ATR on Quality Control Check Report. (Apartments)

Quality Control Check Report Stage: After Finishing Stage III (Apartments)

GULMOHAR RESIDENCY

Details of Additions & Alterations

Changes in kitchen platform: (mark on plan)

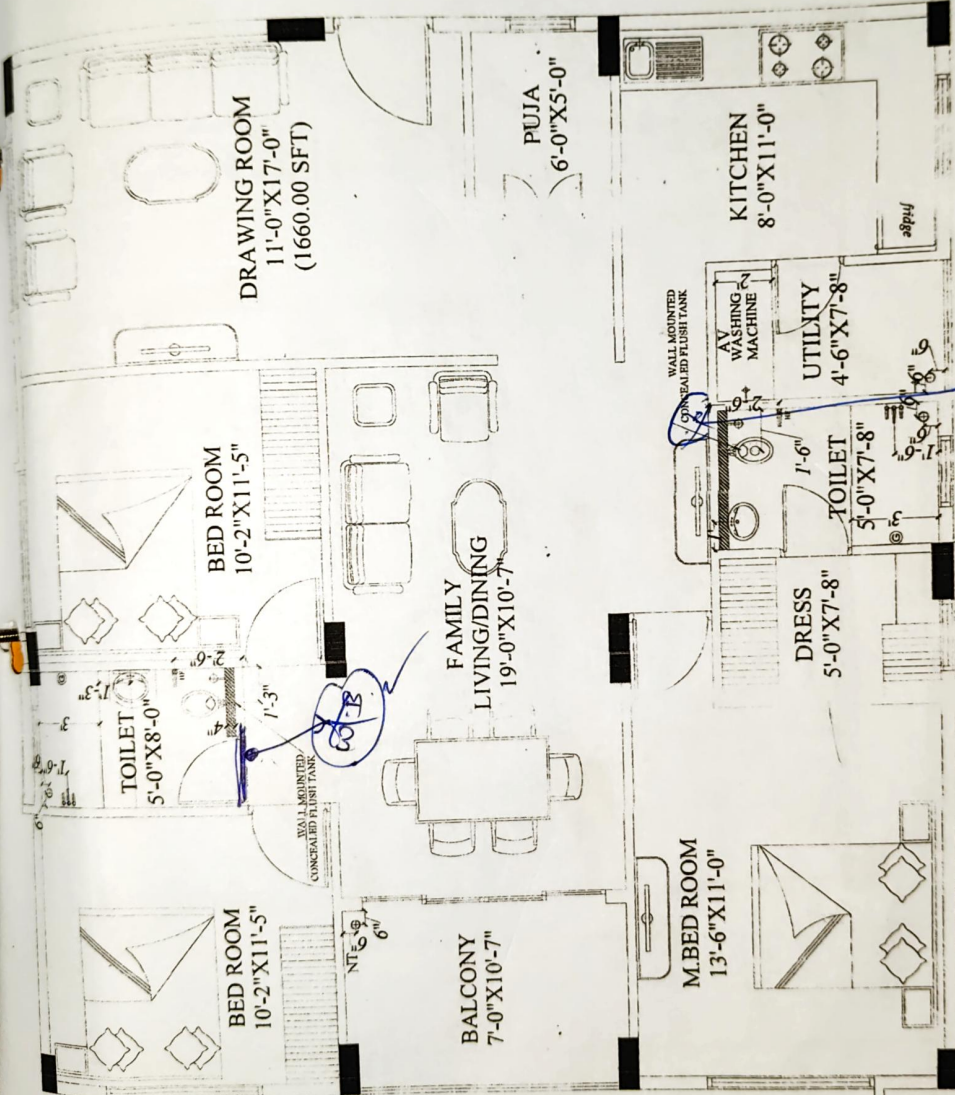
① Modular kitchen by customer

- 1) 6'3" wall has to be removed.
- ② ~~Perja wall has to be removed~~ as mentioned in drawings. Remain as same as original plan don't remove wall.
- ③ Perja door frame & wall not required.
- ④ shift washroom door to left side wall from children's B.R. as shown in plan
- ⑤ ~~Extra wash basin as Common Bathroom~~
Passage area X
- ⑥ kitchen work area should be flat. ✓
- ⑦ m.b window has to closed beside washroom.
- ⑧ Between 2 children's bed room wash basin has to fix. ^{plg} 30/11/22.
